BT-02-2013 EUROCOPTER ECUREUIL AS350B3

ASUNTO: INSPECCIÓN DE TIEMPO DE LOS LIMITES DE MANTENIMIENTO - ROTOR DE COLA (TRH) BASE DE LAS VARILLAS DE CAMBIO DE PASO

**ALERT SERVICE BULLETIN
05.00.74 Revisión No. 1**

SUBJECT: TIME LIMITS/MAINTENANCE CHECKS - TAIL ROTOR - Tail Rotor Hub (TRH) pitch horn

Figure 1: Areas to be checked for cracks

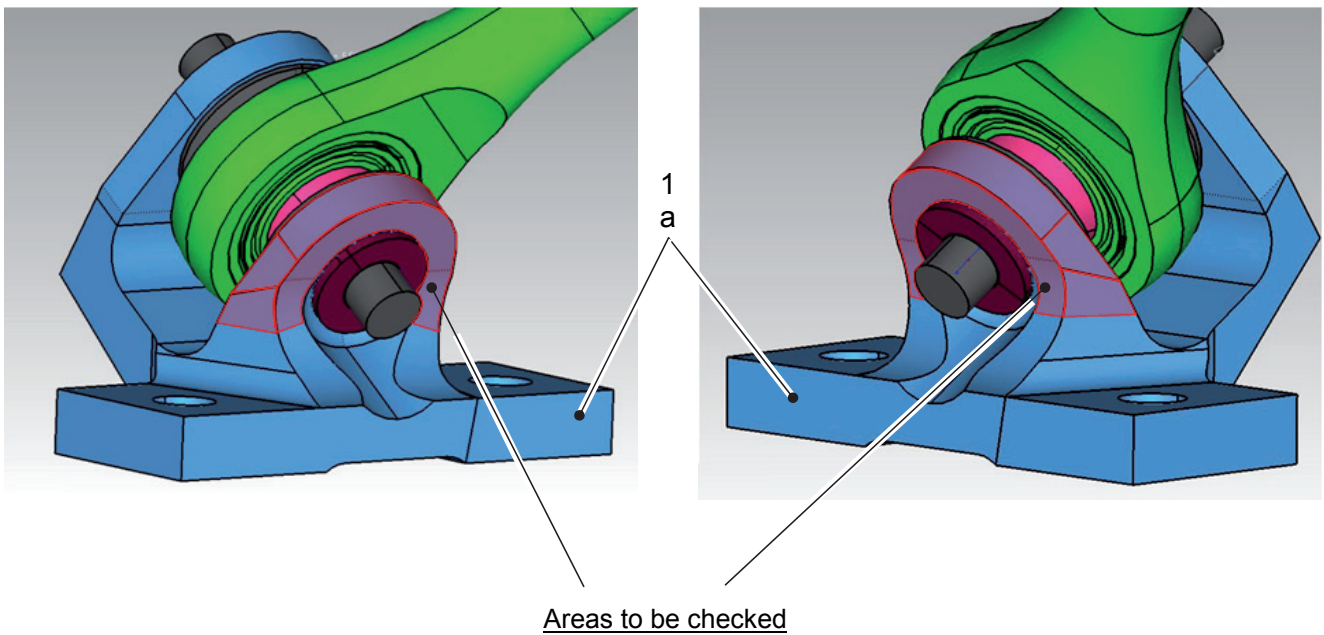
Visually check that there are no cracks on the inner yoke of the two TRH pitch horns (a) (Figure 1, DETAIL A and B). If in doubt, carry out a dye-penetrant test.

- case 1: no cracks detected on the two TRH pitch horns: leave as is and proceed with the final steps as per paragraph 3.B.3.
- case 2: at least one crack detected on the TRH pitch horn: remove and replace the incriminated horn as per paragraph 3.B.2.b. before resuming flights.

- Remove the TRH pitch horn (a) as per MRM Work Card 64.10.00.707 or AMM Task 64-10-00,8-2.
- Install the TRH pitch horn (1) as per MRM Work Card 64.10.00.707 or AMM Task 64-10-00,8-2.
